20-087MPR – SZUTER RESIDENCE

20-087ARB
Architectural Review Board
Szuter Residence - Pool & Pool House
80 Franklin Street

Pool and Pool Deck

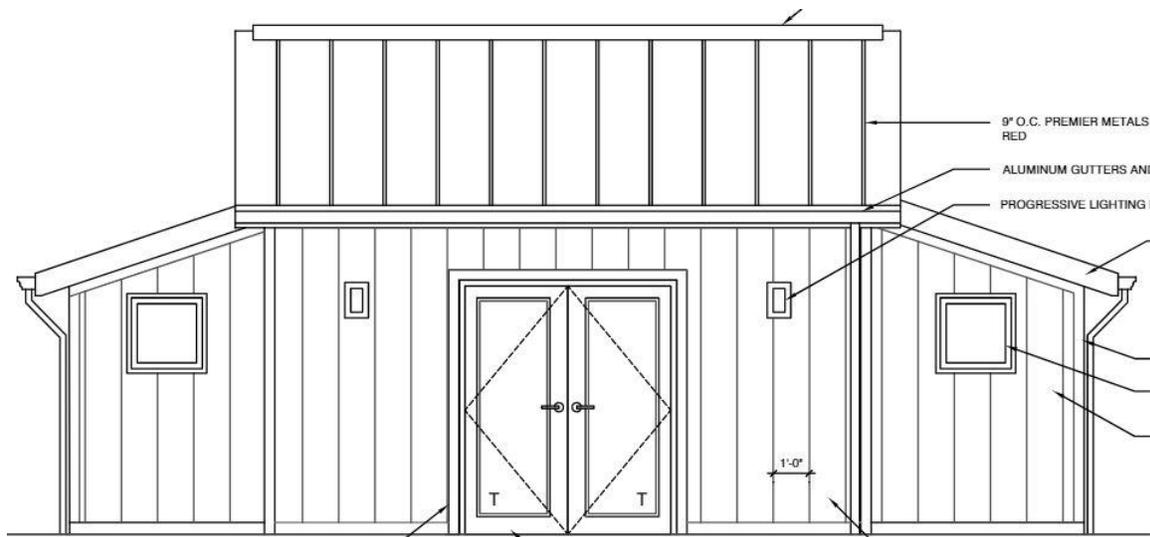
The applicant is proposing an irregularly shaped concrete pool deck, approximately 30 feet in width by 60 feet in length, to surround the new 790-square-foot in-ground pool. At its closest point, the pool deck will be located 6.5 feet from the north property line, meeting the Code required minimum setback of 4 feet. The existing detached garage is set back 5.5 feet from the south property line. In combination with the pool deck setback from the north property line, the proposal exactly meets the Code required minimum side yard setback sum of 12 feet. All other structures on the site, including the proposed pool house, meet setback requirements. The applicant has indicated that the total lot coverage, including the pool and pool deck, existing home and detached garage, and the proposed pool house is approximately 35-percent, where a maximum 50-percent is permitted.

The applicant is also proposing a 4-foot tall pool barrier, as required by Code. The barrier is a Delgard Aero ornamental fence, prefinished in black. The gate will be located at the southwest corner of the pool deck, will match the rest of the barrier, and will be self-latching. The pool barrier is proposed to encroach into the required side yard setback on the north side of the site, which is permitted, as it is a required safety provision.

Staff is concerned that pool mechanicals are not shown on the site plan. Staff recommends that the applicant continue to work with Staff to ensure that all pool mechanicals meet required setbacks and are screened, as subject to Staff approval.

- 1) That the applicant continue to work with Staff to ensure that all pool mechanicals meet required setbacks and are screened, subject to Staff approval.
